OREGON PARKS & RECREATION DEPARTMENT  
5330 Seaman Road  
Oregon, Ohio 43616  
(419) 698-7145  
FAX (419) 698-7086

**ADDENDUM No. 1**  
**Recreation Buildings - 2023**

Plan holders of the Recreation Buildings - 2023 Project are hereby notified of the following amendments to the Contract Documents. The following additions, alterations, deletions and/or clarifications shall be part of the bid specifications as much as if they were originally included in the Contract Documents. This Addendum No. 1 is hereby made a part of the Contract Documents and must be receipted for on the proposal form.

E2.1

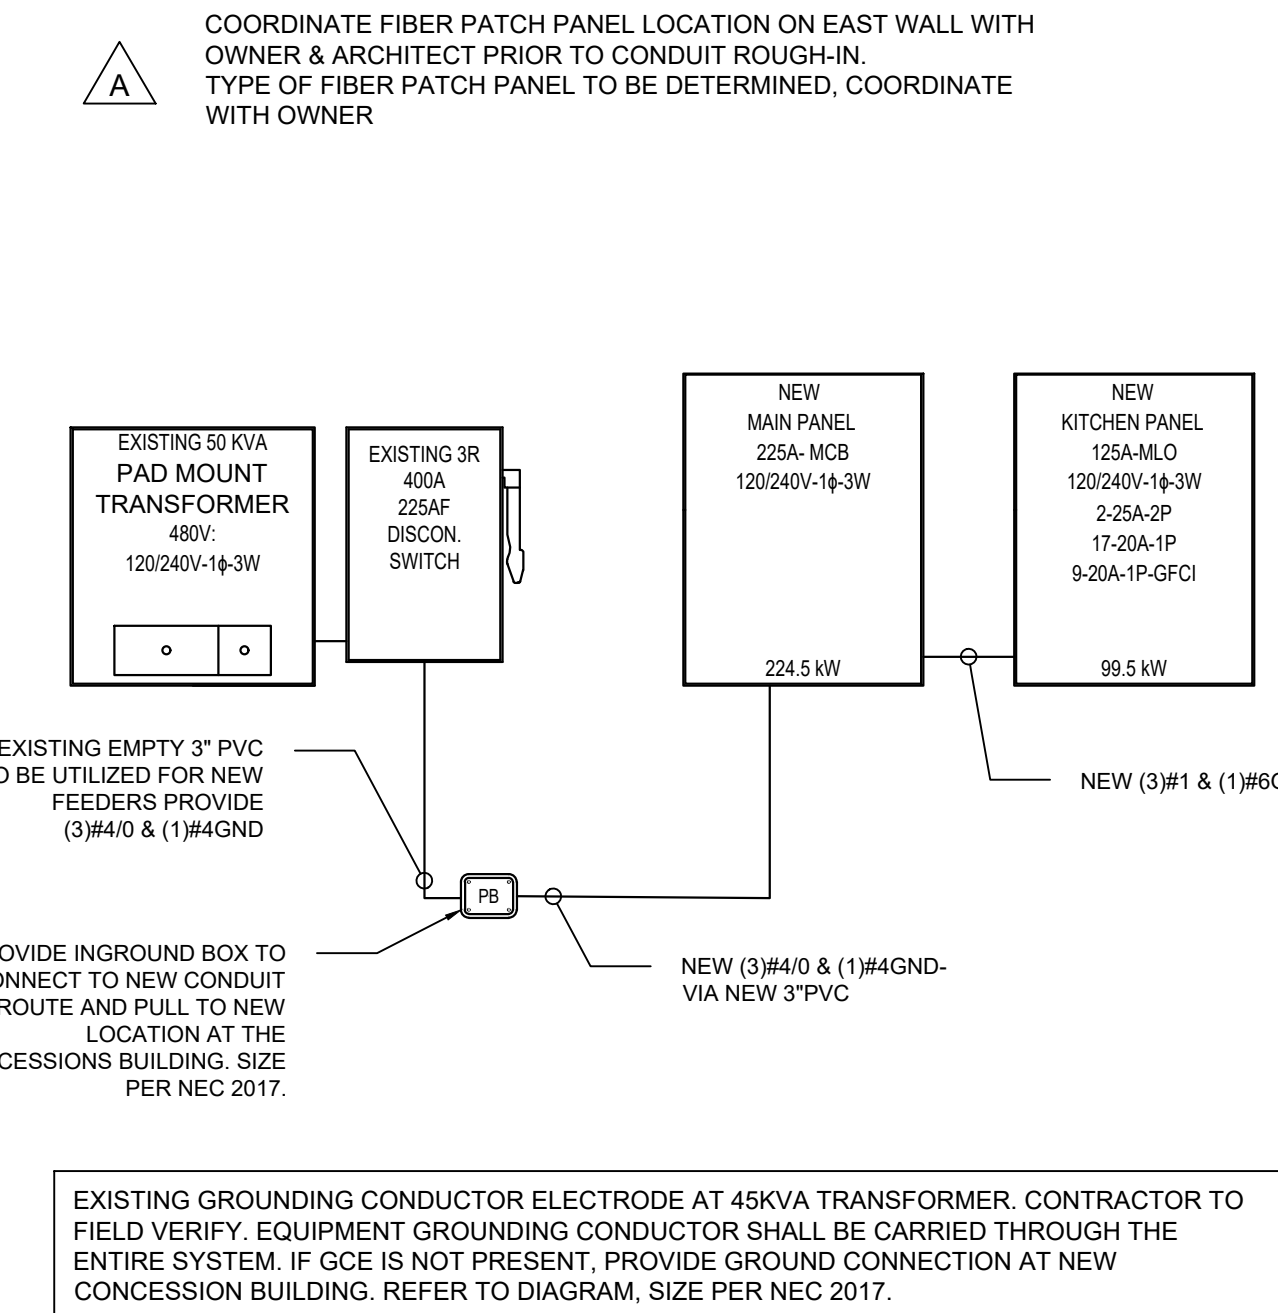
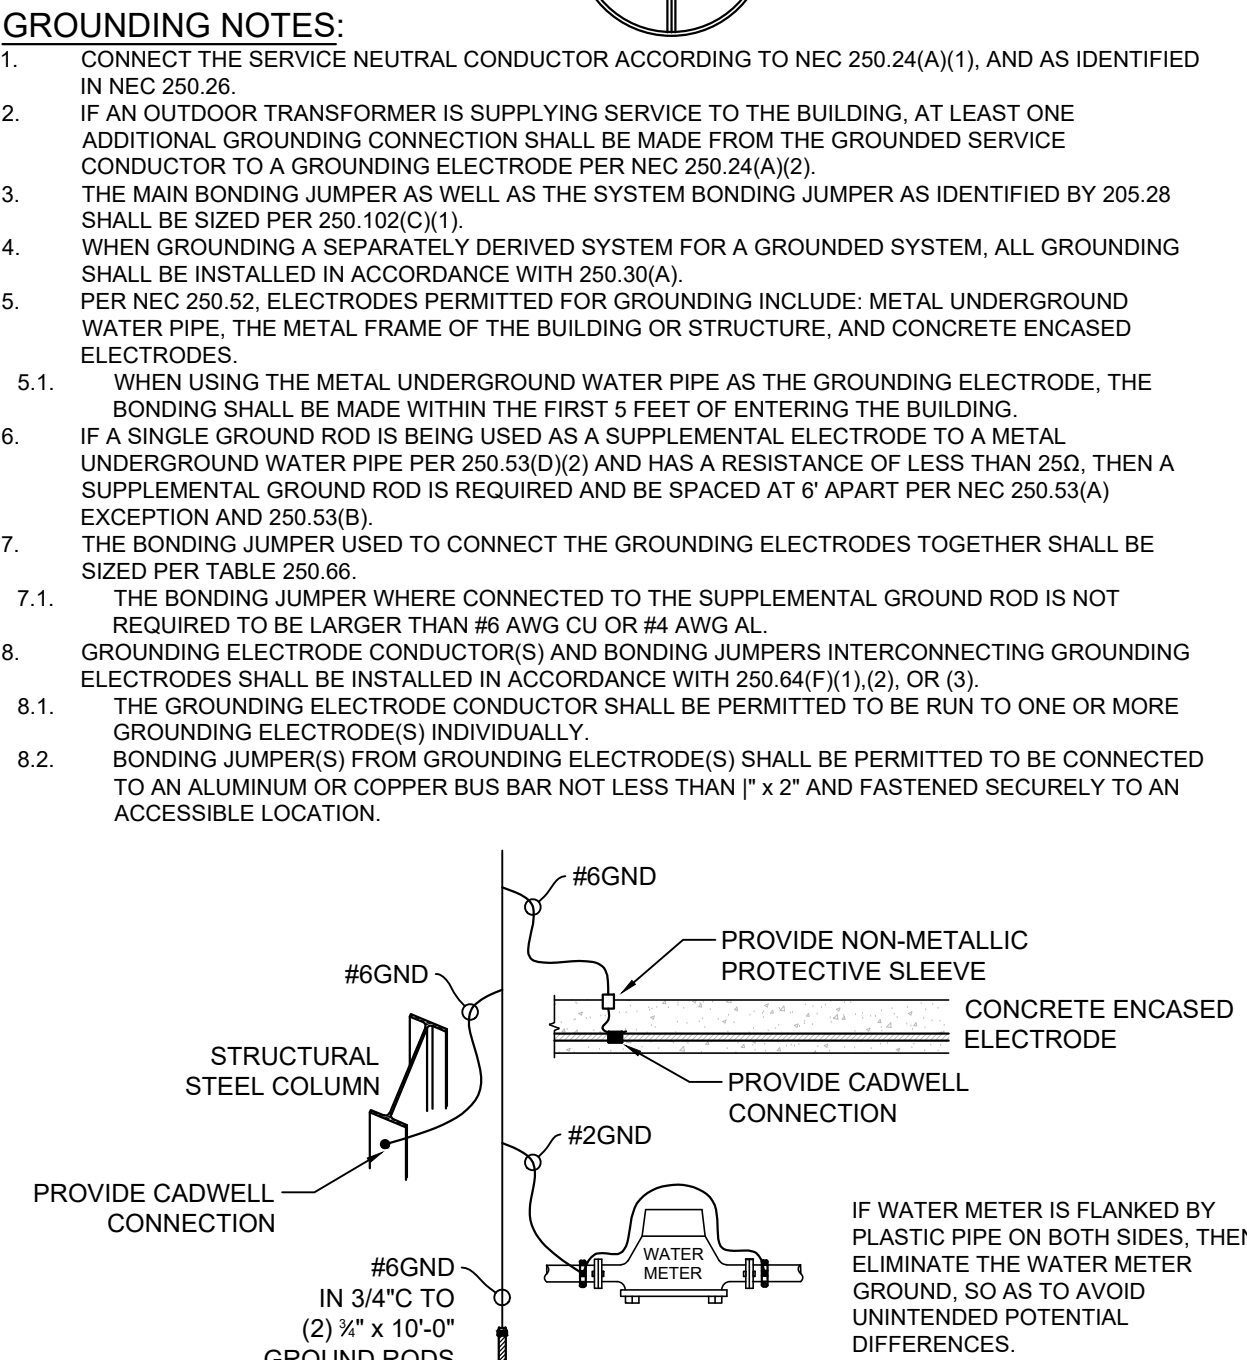
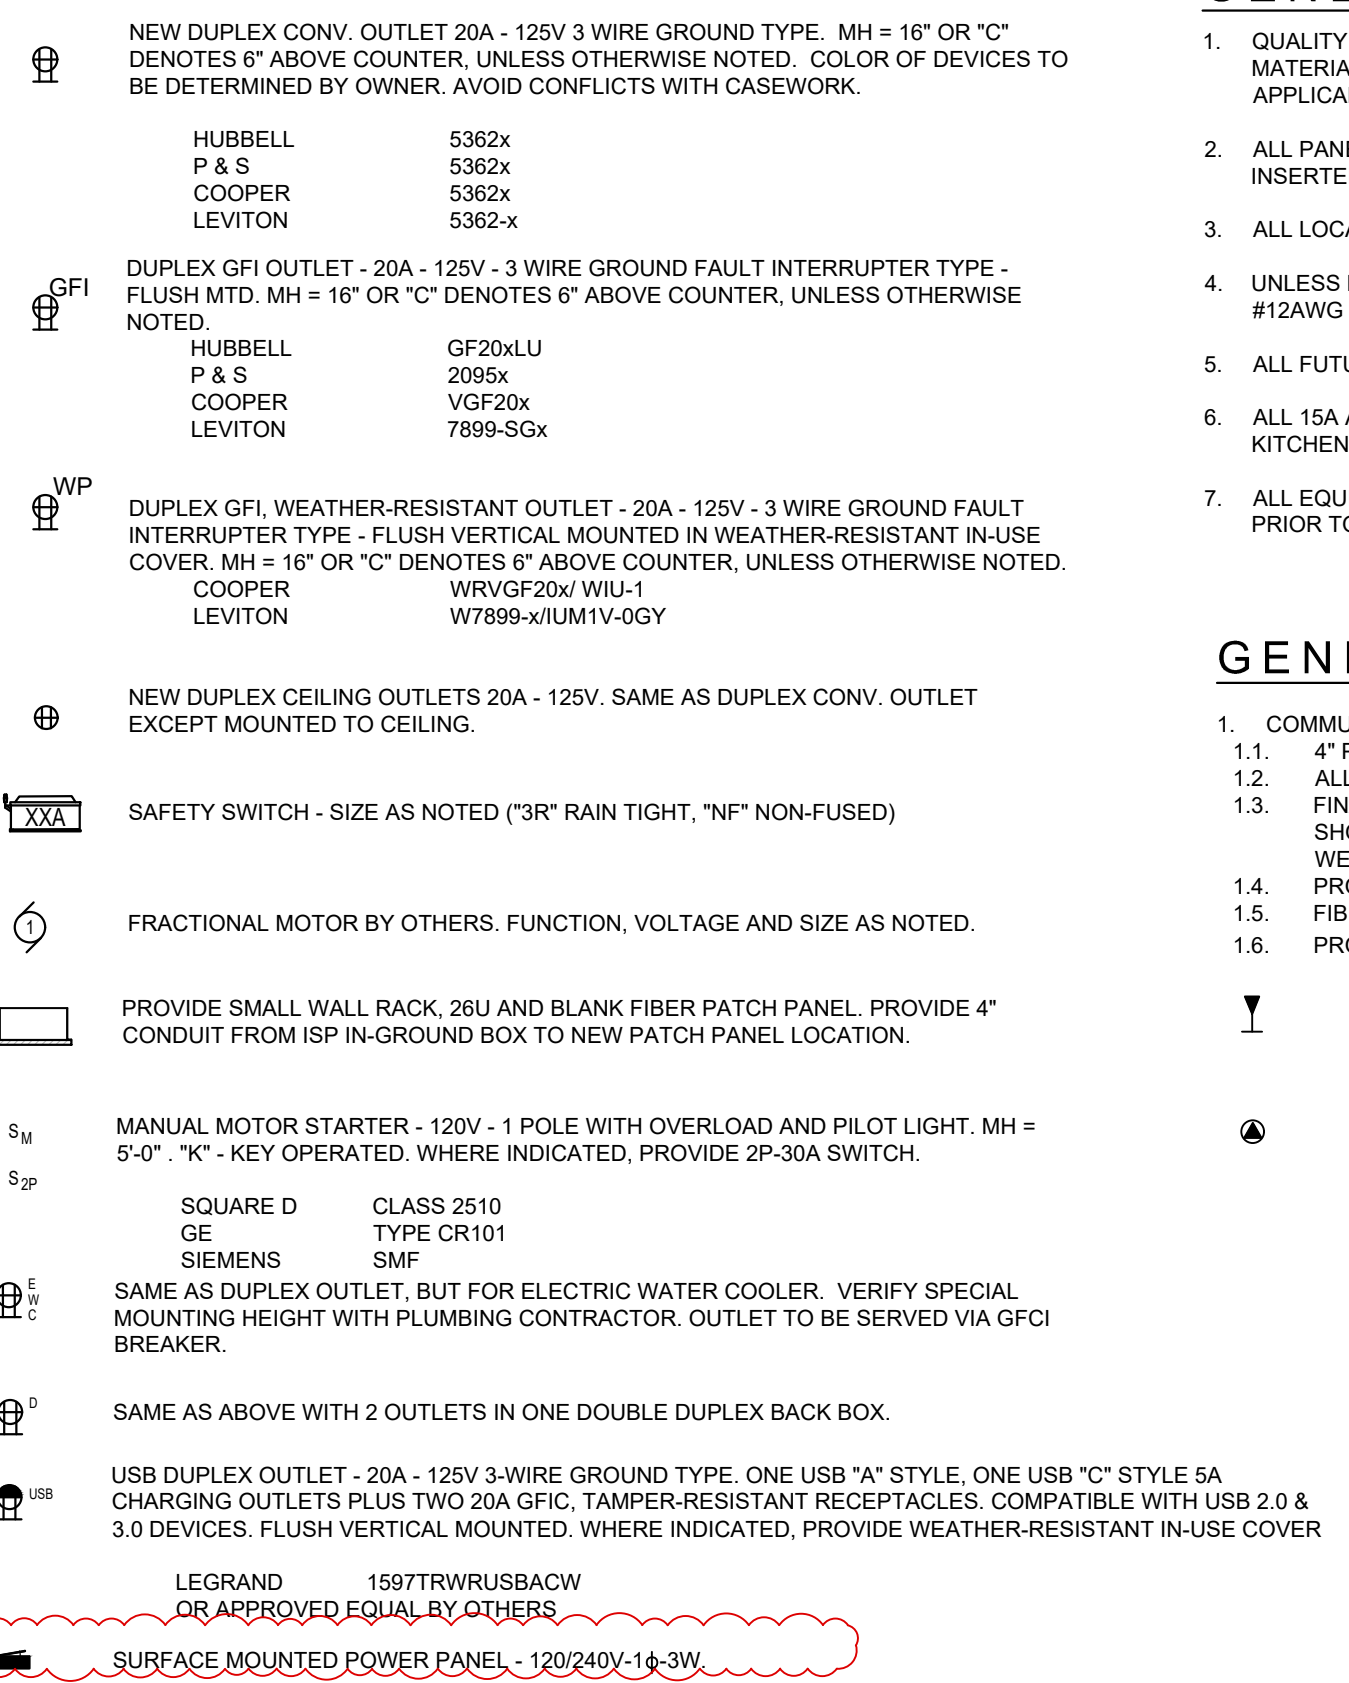
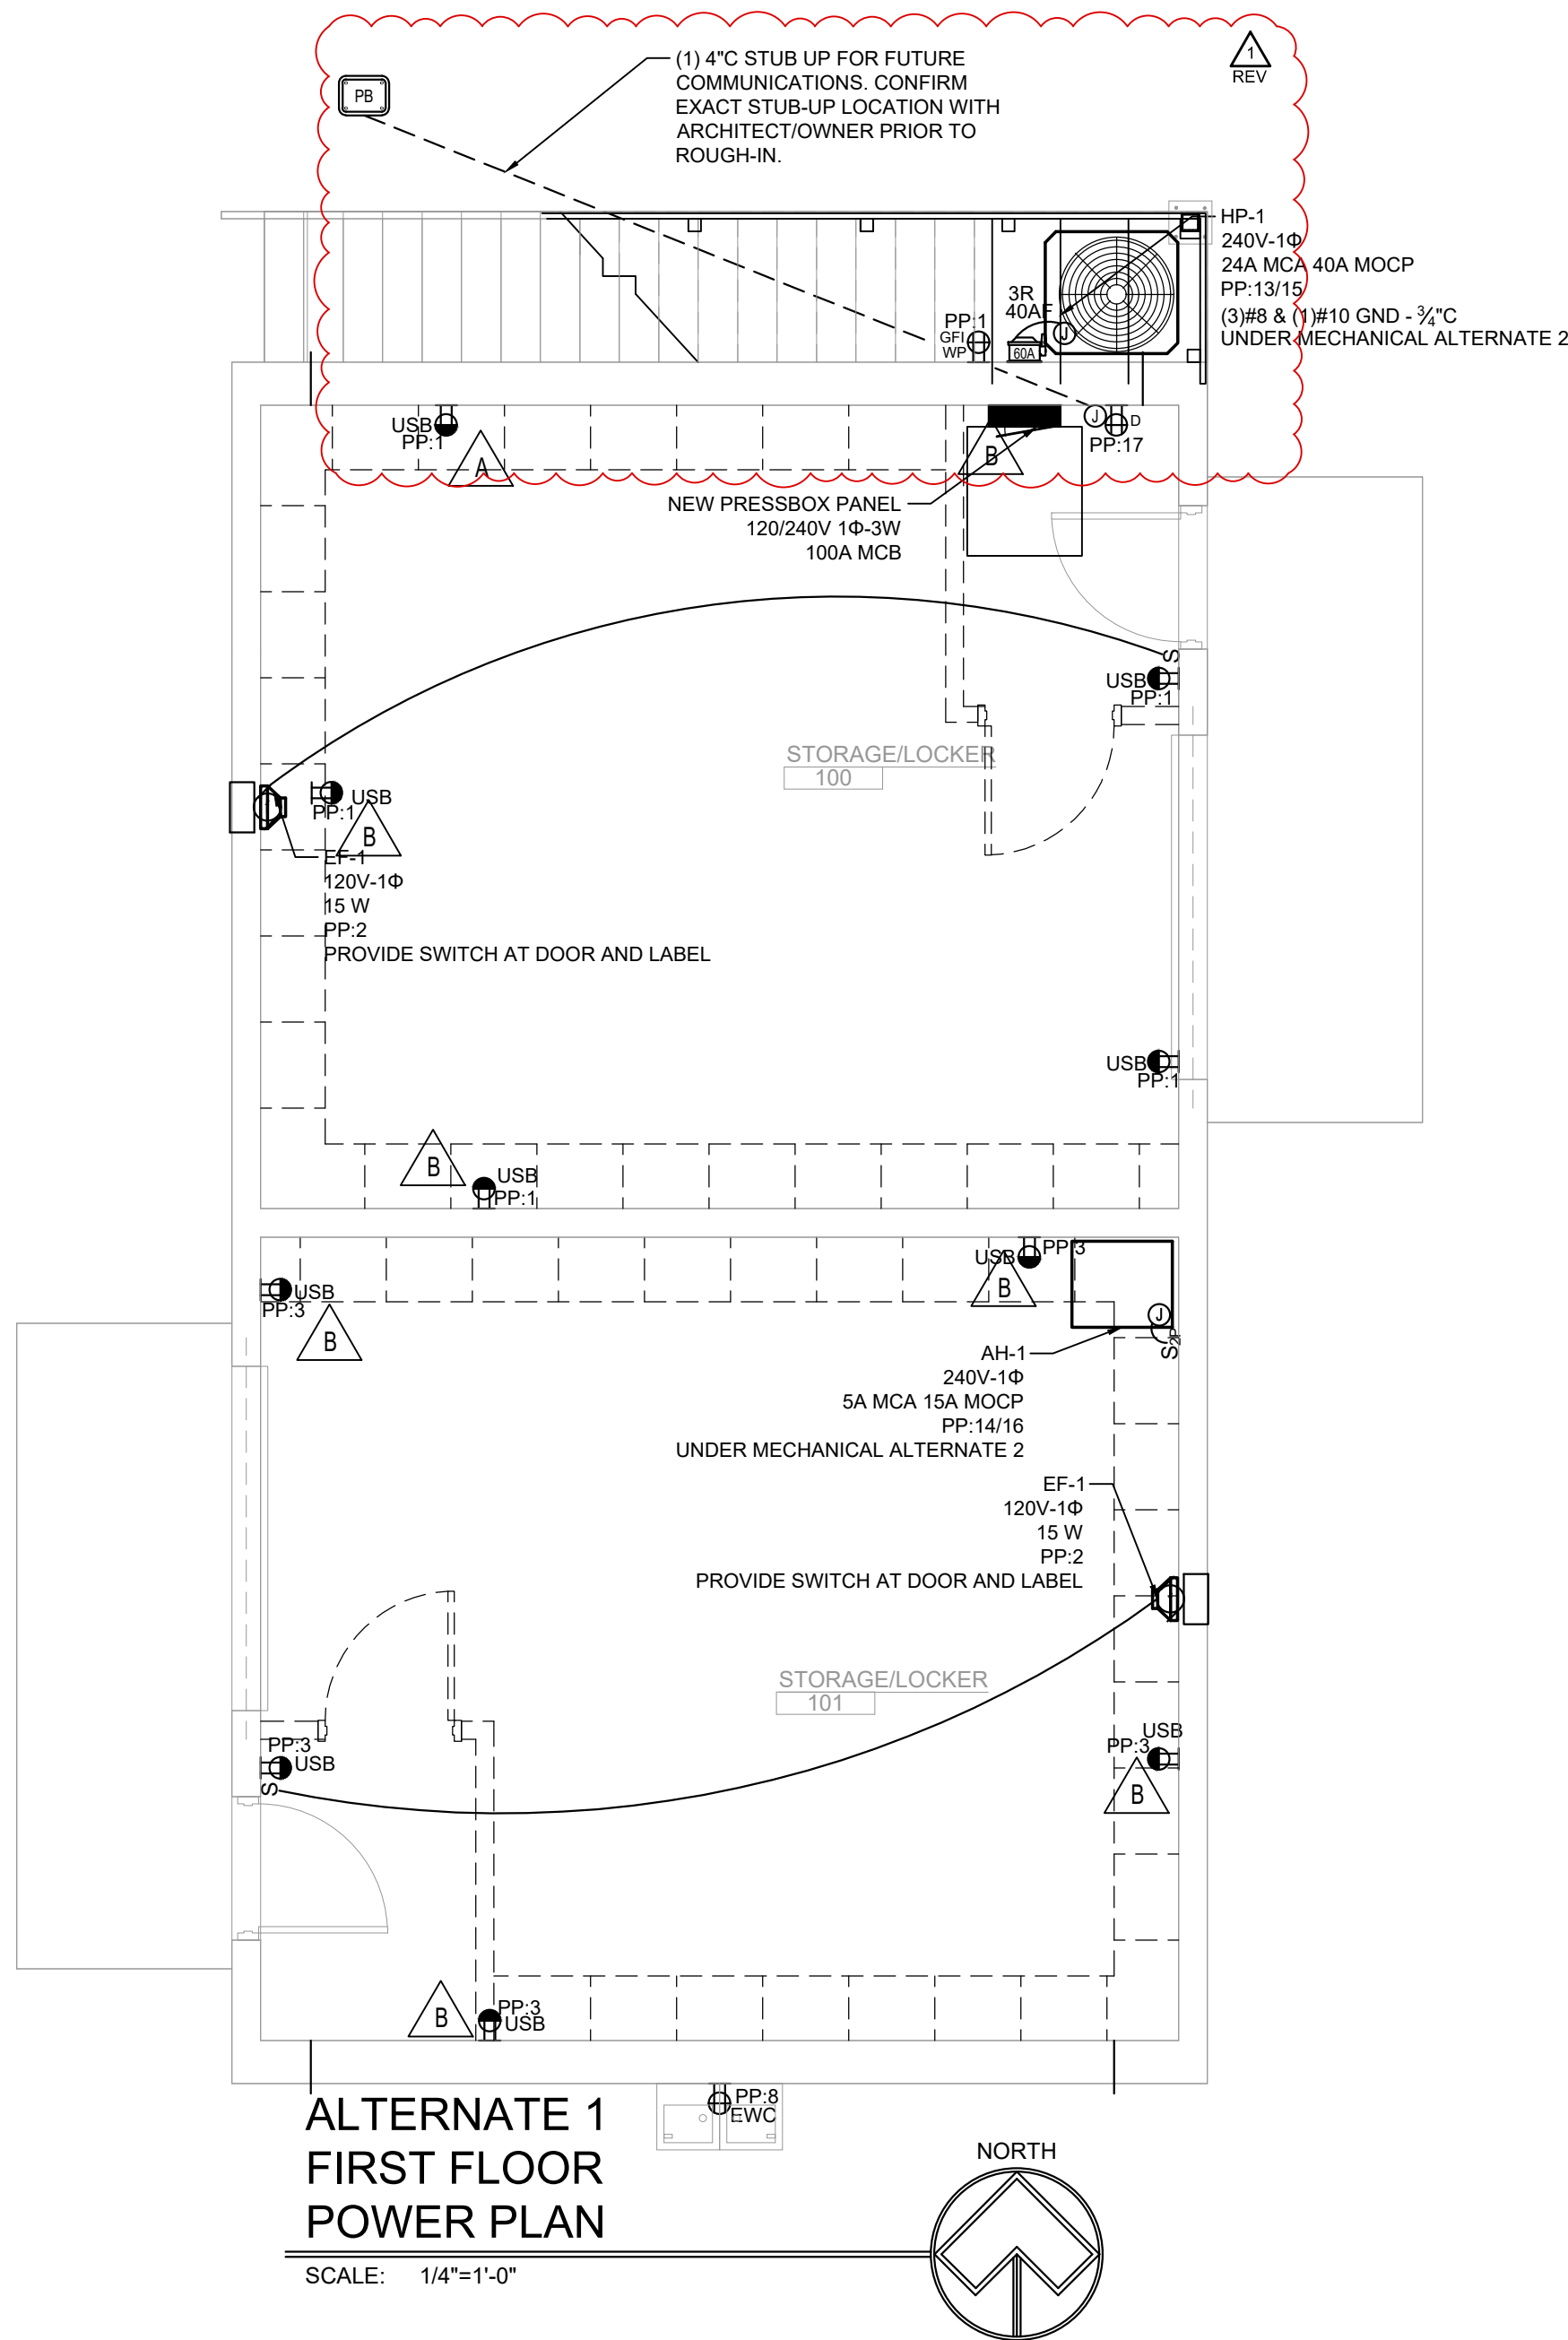
- 2) **Bidder Question:** *It appears that all of the electrical panels are flush mount in block walls with hard ceilings above. I have a few concerns about this.*
- *This eliminates access for “future” customer needs.*
  - *The block walls will be full of conduits instead of insulation/grout which would cause condensation issues in the panels.*
  - *The panels are very close to windows and doors. This will cause conflict with masonry supports and rebar inside of the walls.*
  - *The top plate and sills would be almost nonexistent due to the conduits leaving the panels.*
  - *Is there any chance the customer may change their mind on recessed breaker panels? Maybe build a wooden chase around the conduits to hide them at the panel location?*

- 3) **Bidder Question:** *Sheet E2.1 It looks like there will be a clearance issue between the Kitchen panel and the Patch panel. Please advise.*

**Architect/Engineer Response:** (2) electrical panels have been revised to be surface mounted (Pressbox and Concession Main panel). Electrical panel in the kitchen (panel K) shall be recessed in drywall & insulation added for condensation protection. See attached revised drawings A1.1, E2.1, & E2.2.

**Architect/Engineer Response:** Locations of panels have been adjusted. Refer to sheet E2.1
